APPLICATION NO.	FILING DATE	FIRST NAMED INVENTOR	ATTORNEY DOCKET NO.	CONFIRMATION NO.
09/910,720	07/24/2001	James P. Hearn	8932-177	1799

Office Action Summary

DETAILED ACTION

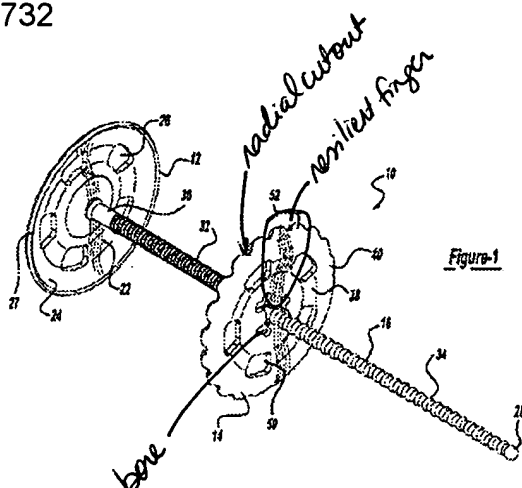
Regarding claim 83, opening 59 includes a countersink or an "enlarged opening" defined by the cutouts (Figures 1 and 3).

Regarding claim 84, second clamping member 14 has a recessed area 38 proximate or "very near" circular opening 59 receiving stop 32 (Figure 1).

Regarding the limitation, "so that movement of the clamping member.....flatten out allowing the clamping member to at least partially conform to the outer surface of the bone flap and skull, Herrington et al. disclose that second clamping member 14 has resilient fingers defined by radial cutouts and bores 60 which will cause the clamping member to at least partially conform to the outer surface of the skull (col. 4, lines 59-67 and col. 5, lines 1-17). See marked up Figure 1 on the following page.
